SUMMARY EXPERT OPINION INDEPENDENT VERIFICATION: OVERSHADOWING IMPACT

PROPOSED MIXED USE DEVELOPMENT 2 Mark St, 1-3 Marsden St, Lidcombe

12 November 2018

Figure 1: Geolocated detailed model in SketchUp. View from the sun at 3.00pm June 21 (Option 1)

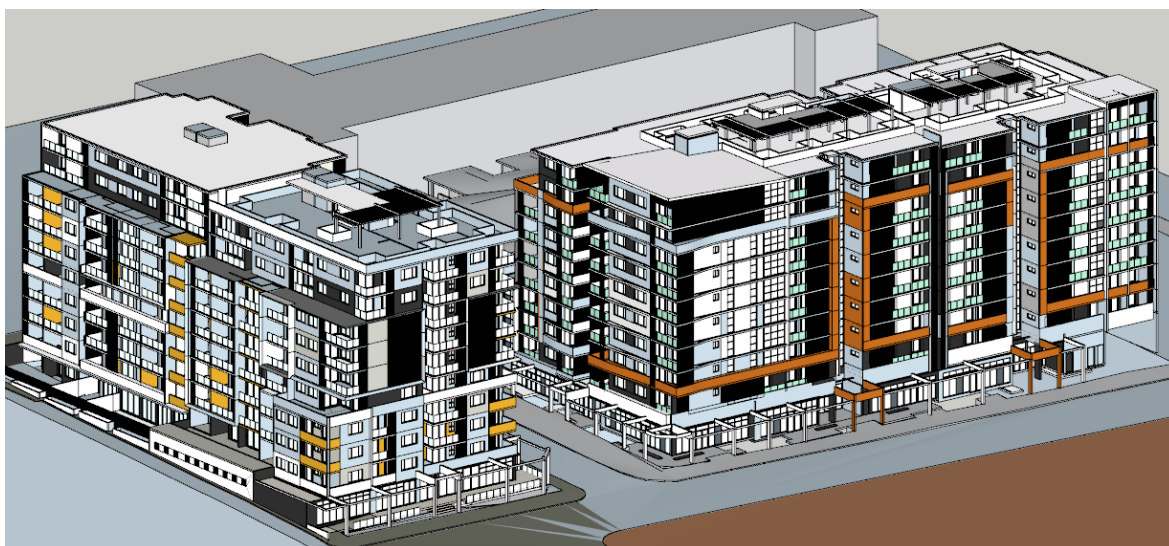
Figure 1 shows that the subject building does not overshadow the affected building at 3 PM. Therefore, any apartment which has complying sun by 1 PM can be said to achieve the minimum two hours of unobstructed direct sun on June 21.

Figure 2: View from the sun 11 AM

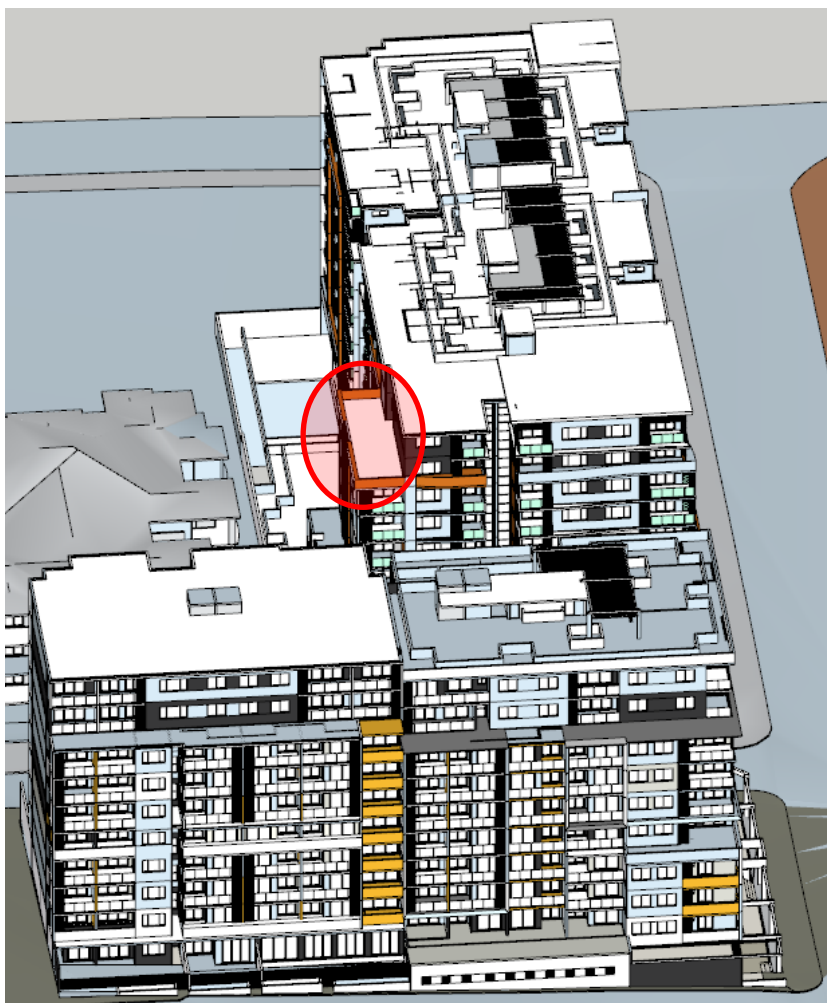
The applicant provides a detailed compliance table on sheet 8539 DA - E:25H: Shadow Impact to 4-14 Mark St (Winter Solstice) *OPTION 1*.

In that table, Units 1.09 to 7.09 and Units 8.07 – 9.07 are characterised as losing solar access compliance due to overshadowing by the subject building. In fact, examination of the view from the sun at 11 AM (Figure 2) shows Units 1.09 to 7.09 to be self shaded, and Units 8.07 – 9.07 to be too high to be externally shaded by any building of similar height.

In brief, no apartment on the eastern façade of 4-14 Mark Street loses solar access compliance as a consequence of overshadowing by the subject building.

Figure 3: 1 PM overshadowing for Option 1

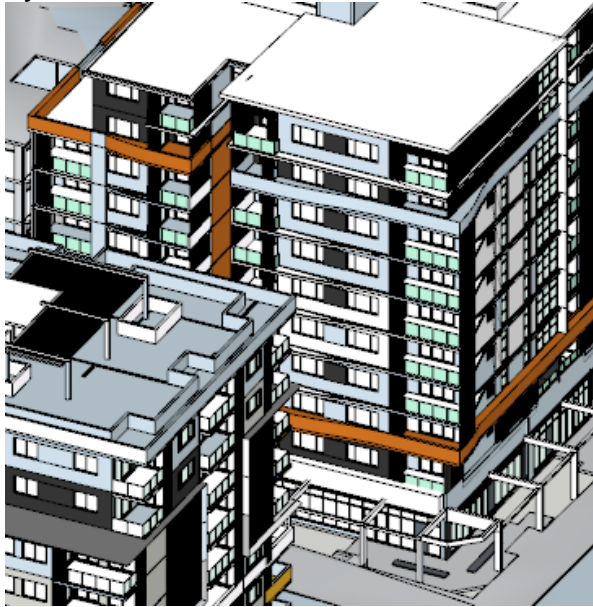
Figure 3 compares my view from the sun, and the applicant's conventional elevational shadows for the North elevation of the affected building, as shaded at 1 PM by the DA scheme (Option 1).

The view from the sun confirms that before 1 PM the subject building cannot overshadow the western elevation of the affected building – therefore additional afternoon overshadowing can only occur on the north façade.

If I focus on the north-east corner, I confirm that the applicant correctly identifies eight units in the lower storeys which do not receive direct sun at 1 PM. Therefore those eight individual apartments lose solar access compliance due to overshadowing by the subject building.

Figure 5: 1 PM overshadowing for DA and amended schemes

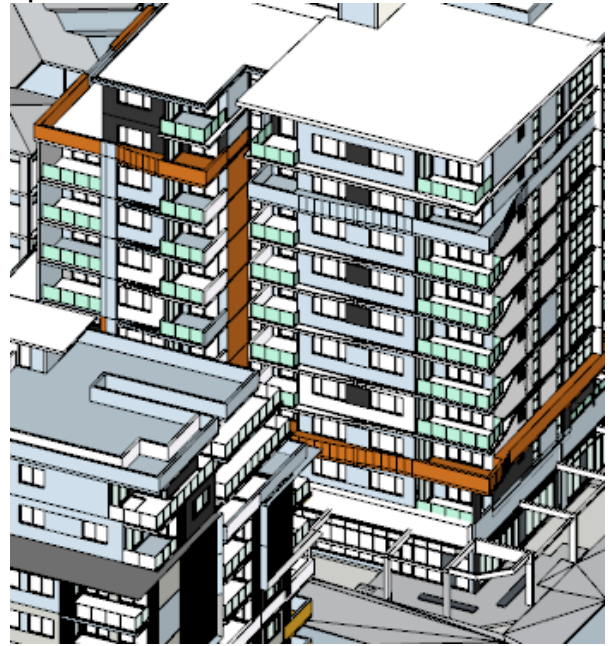
Figure 5 compares the views from the sun at 1 PM for Options 1 and 2.

If I again focus on the north-east corner, I observe that an additional three units now have complying sun at that time. Therefore the amended scheme (Option 2) reduces the loss of solar access compliance by three individual units, compared to Option 1.

The overshadowing impact of Option 2 is to reduce the overall compliance of the affected building by 5/165 (3.0%).
